Baseline Comment Bucket

Comment Bucket Buckets

Figure 33-8—PSE detection source

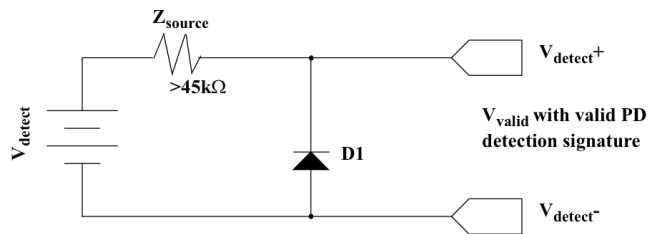
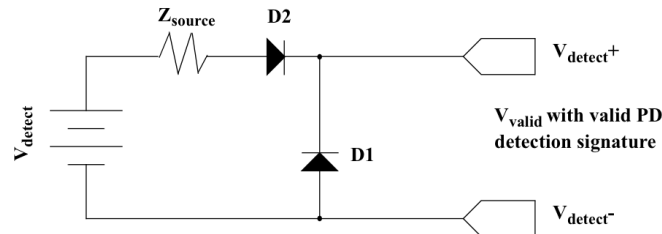
CI 33	SC 2.5	P 33	L 5	# 13
LANDRY, MATTHEW		SILICON LABS		
Comment Type	TR	Comment Status	D	baseline
A PSE performing detection should be able to provide two characteristics.

(1) Probing into a short circuit won't destroy the PSE or the source of the short.				
(2) Two PSEs probing the same link segment should not result in a 25kohm differential impedance.				
The probing voltage (V_{valid} and V_{oc}) and short circuit current limit defined in Table 33-2 accomplish (1). A simple shall statement can accomplish (2).				
Instead we have some schematics (Figs 33-8 and 33-9) and a normative statement requiring conformance to them. This sure sounds like mandating an implementation -- and unnecessarily at that.				
<i>SuggestedRemedy</i>				
Strike Figs 33-8 and 33-9 or add a NOTE mentioning that they are informative only.				
Strike Thevenin shall statement on line 45.				
Add the following shall: A PSE shall present a non-valid signature as defined in Table 33-9 in all detection states.				
Note that current PSEs conforming to the Thevenin circuits currently mandated will still satisfy this new shall.

- ◆ Not required for current limitation
- ◆ Does not force misdetects
- ◆ Does not force detects
- ◆ How is this PICs testable?
- ◆ Suggested remedy “shall” statement may also be difficult to test
- ◆ More discussion needed
